World Forum for Harmonization of Vehicle Regulations**Working Party on Lighting and Light-Signalling****Seventy-first session**

Other business – Any other business**Proposal for draft amendments to Regulation No. 104 (Retro-reflective marking for vehicles of category M, N and O)****Submitted by the expert from the European Association of Automotive Suppliers***

Figure 3
Retro-reflective material marking of class F

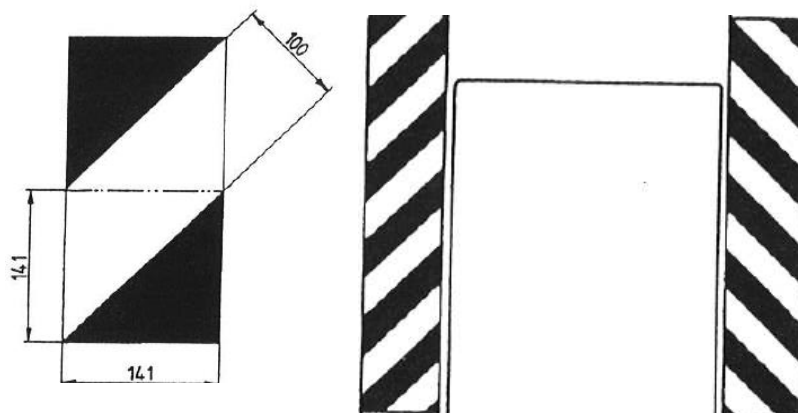
2.2.1. Class F retro-reflective materials shall consist of red and white diagonal stripes each 100 mm wide sloping outwards and downwards at 45°. The basic standard area is a square of 141 mm in length subdivided diagonally into a white half and red half, which represents one standard area as shown in Figure 3.

2.2.2. The minimum length of an element of a retro-reflective marking material shall incorporate a minimum of 9 standard areas as described in paragraph 2.2.1. above on large vehicles with available mounting space, but may be reduced to a minimum of 4 standard areas on vehicles with limited mounting space.
